ADDENDUM NO. 1

TO: All Bid Packet Holders
FROM: City of Kenai Public Works Department
DATE: June 23, 2020
SUBJECT: Invitation to Bid – **Kenai Beach Vault Restrooms**
DUE DATE: ***June 29, 2020, by no later than 2:00 PM***

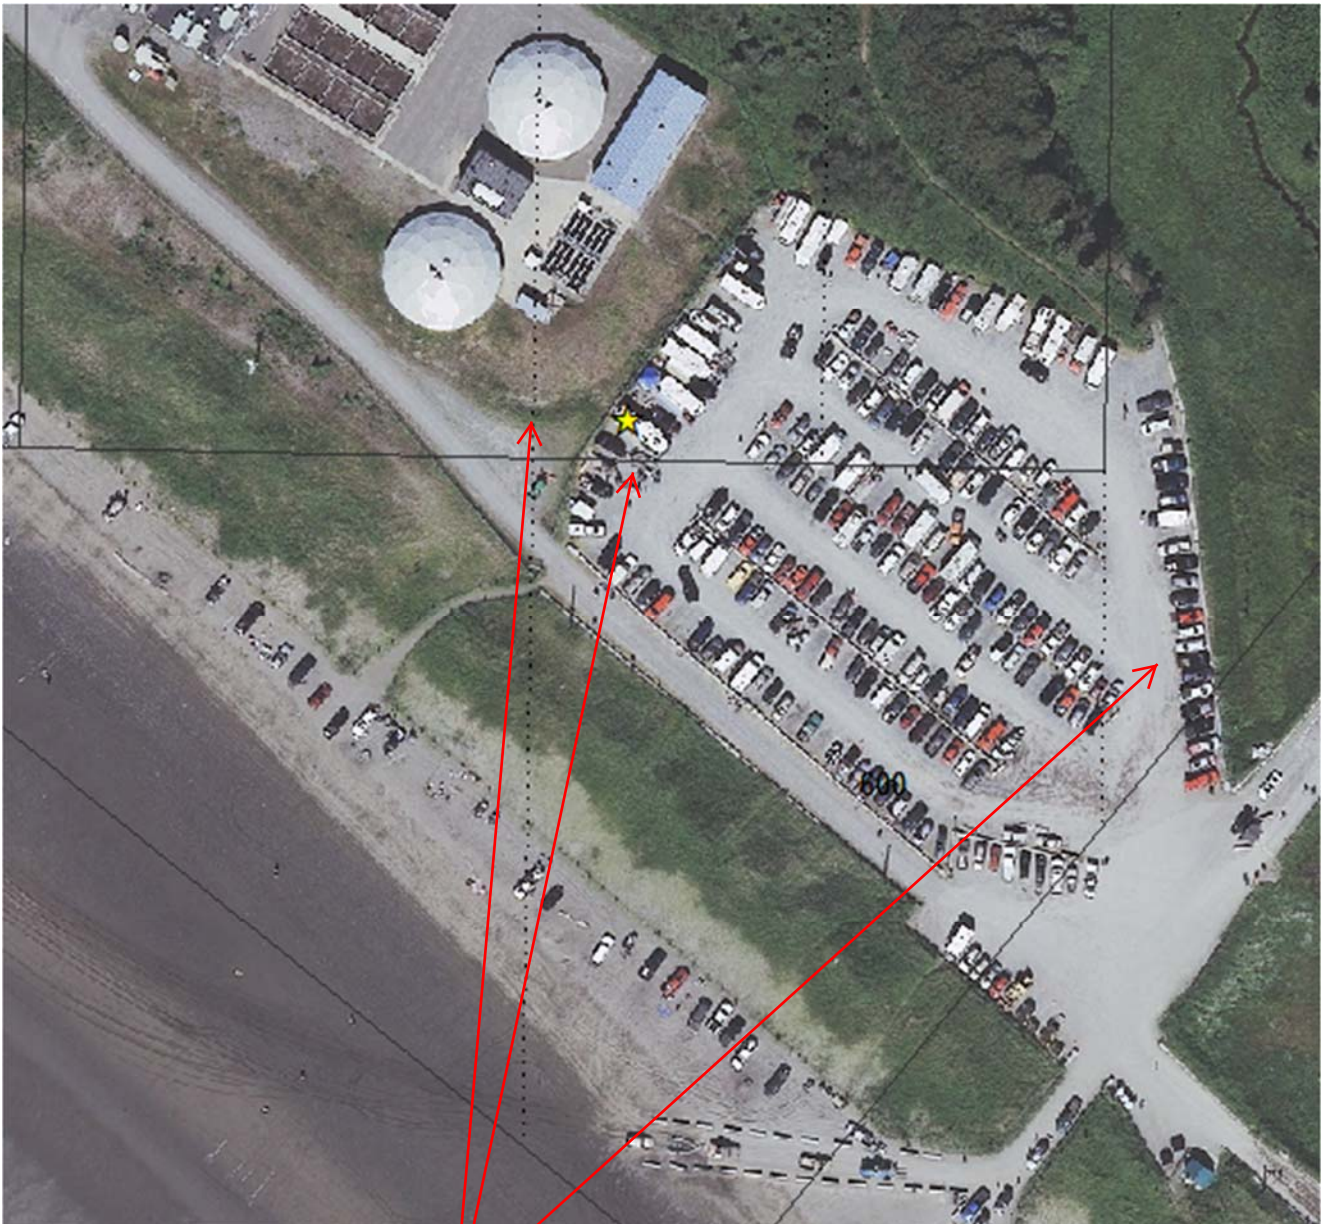
Response: Roofing Attachment. On Sheet S 5.0 delete the note: "Vertical Seam UL-90 Clip @ Seams, Spacing 4' o/c"

And replace it with: Vertical Seam UL-90 Clip @ Seams, Clip spacing and fasteners per S2.0"
